## Product Change Notification / RMES-02CRED041

CCB 4325 Initial Notice: Qualification of MPHL as an additional final test site for selected Atmel ATSAM10Exxx and ATSAM11Exxx device families available in 32L VQFN (5x5x1.0mm) package.

**CCB 4325**  
**Pre and Post Change Summary**  
**PCN #: RMES-02CRED041**

**QUALIFICATION PLAN SUMMARY**

# Tray Packing Procedure – No change

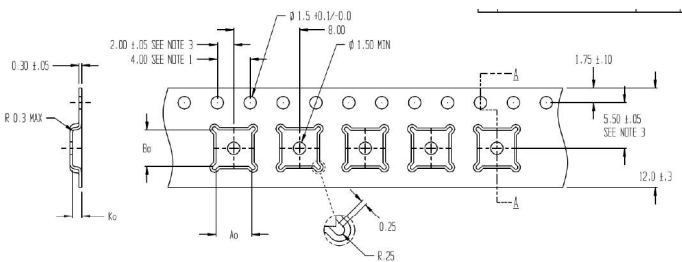
**TRAY BUNDLING:**  
3 straps crosswise & 1 lengthwise  
Max: 10 full trays + 1 empty tray cover

Inner Box Tray: 16.2x37.1x8.8 cm

# Tape and Reel - Carrier Tape – No change

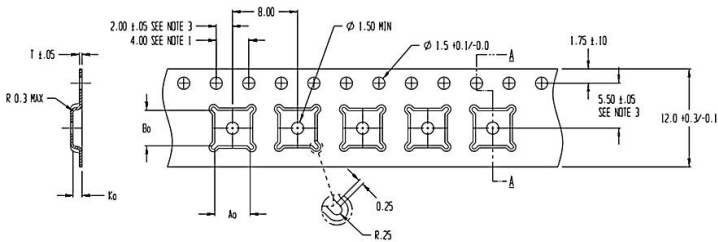
Width (mm)	Pitch (mm)	A0 (mm)	B0 (mm)	K0 (mm)	Thickness (mm)
12	8	5.25	5.25	1.10	0.30

## Tape and Reel – Plastic Reel – No change

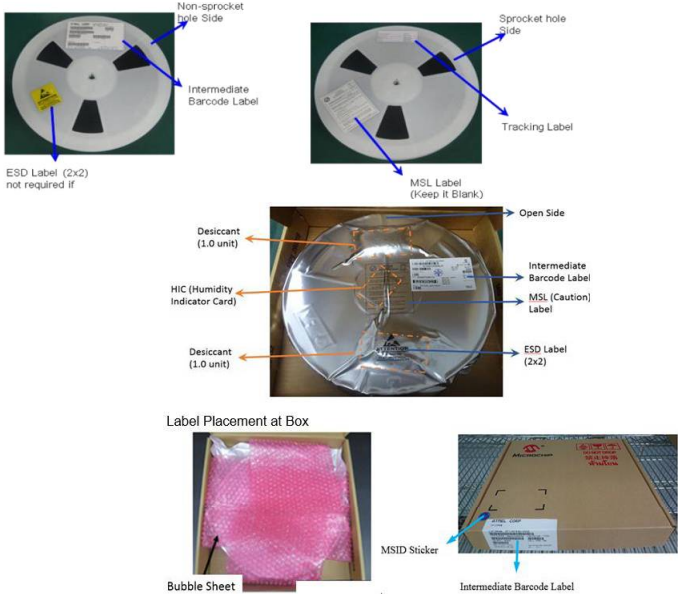
Color	Diameter	Hub Diameter	W1
White	330 mm	100 mm	13.5 +/- 0.5

Color	Diameter	Hub Diameter	W1
White	330 mm	100 mm	13.5 +/- 0.5
